100-100A Chalk Farm Road
Planning prior to above ground works - Condition Variation
Amendment to Condition 21 B

CHALF-RYD-YY-RP-A 121._Prior to above
ground works condition 21

VARIATION OF CONDITION 21 PART B OF PLANNING PERMISSION 2024/0479/P AT 100 CHALK FARM ROAD, NW1 8EH

Acoustic Design Note – Planning Condition 21

Figure 3

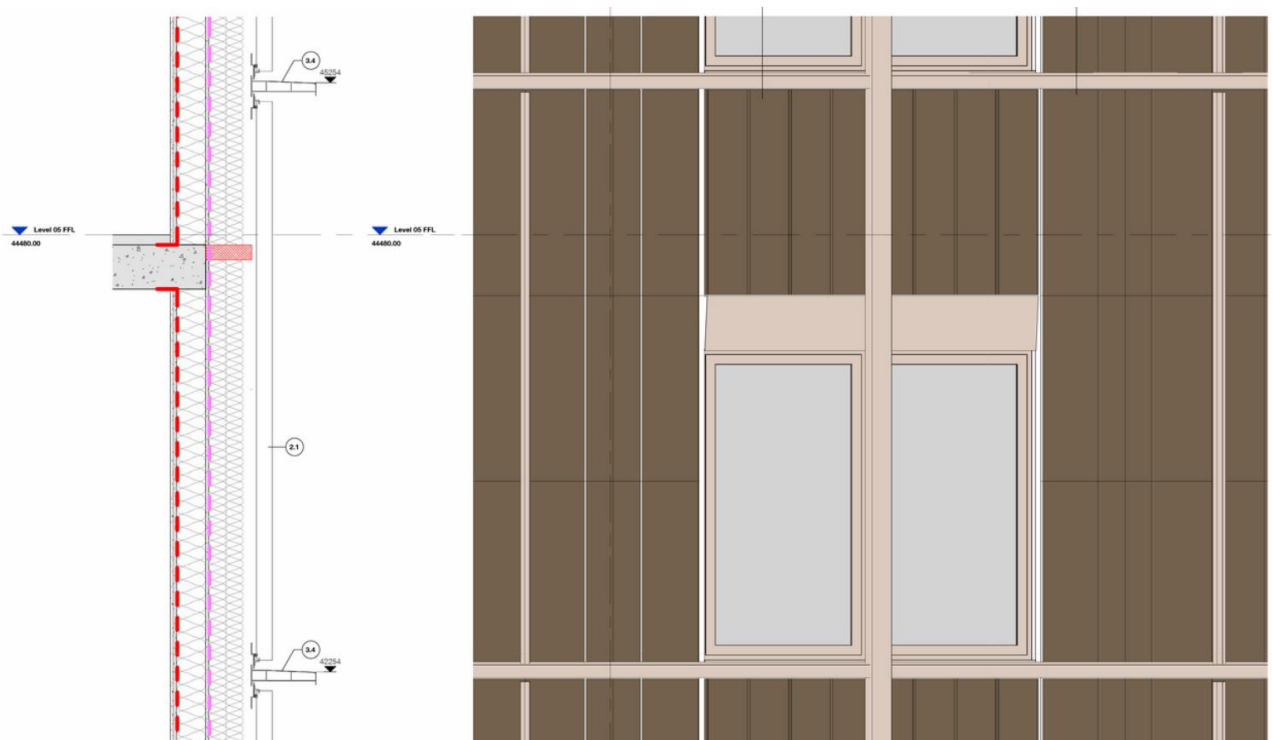
- 2.1 The external façades of Blocks A, B, and C comprise a ventilated terracotta rainscreen cladding on an internal SFS system as shown in the example detail below:

- 2.2 The façade performance design constraint will be achieving the low frequency 63Hz octave band sound insulation performance. Based on the measured event noise level of 75dB $L_{eq,63Hz}$ and the planning condition criteria of 47dB $L_{eq,63Hz}$, the Stage 3 acoustic façade calculations indicate that the façade needs to provide a **minimum sound reduction of 31dB at 63Hz**.

- 2.3 The proposed façade makes use of a ventilated terracotta cladding and therefore the composite acoustic performance is difficult to model accurately due to limitations in the acoustic modelling software, Insul, and lack of available laboratory test data/product information.

- 2.4 Modelling the 'sealed' inner layers of the construction (12mm sheathing board, 150mm SFS with mineral wool, 2x 15mm SoundBloc) provides a minimum sound reduction performance of only 15dB (63Hz).

- 2.5 Following discussions with Rockwool's technical department, the terracotta cladding was modelled as a fully sealed system to give an indication of maximum theoretical performance. Based on a 40kg/m² 40mm thick terracotta tile results in a predicted performance of 33dB (63Hz). Please note that this is considered very optimistic and the ventilated gaps in the terracotta cladding panels will reduce the airborne sound insulation performance by c.5 – 10dB depending on the area ratio of the panel.

- 2.6 As the mass of the Rockwool is not considered within the Insul programme, empirical calculations based on classic 'mass law' ($20\log(f m) - 47\text{dB}$) have been undertaken to estimate the performance of the system with and without the terracotta cladding based on the system mass/unit area:

- 2.7 It is considered that based on the above, the sound insulation performance of the exterior façade build-up is likely to achieve around **25dB at 63Hz** and is therefore unlikely to be suitable for compliance with the technical acoustic requirements of Condition 21.

- 4.5 Going forward, it is recommended that Limb B of Condition 21 is either omitted or amended to state a maximum entertainment noise level of NR35 in line with the specific guidance in the Camden Local Plan 2017 and Draft Camden Local Plan 2024 based on the arguments set out above. The proposed amended wording of the condition is as follows:

b.) that the sound insulation ensures that noise levels from music/ entertainment noise should be controlled so as not to exceed NR25 ($L_{eq,15min}$) in bedrooms (23:00 to 07:00 hours), and NR35 ($L_{eq,15min}$) within all habitable rooms (07:00 to 23:00 hours).
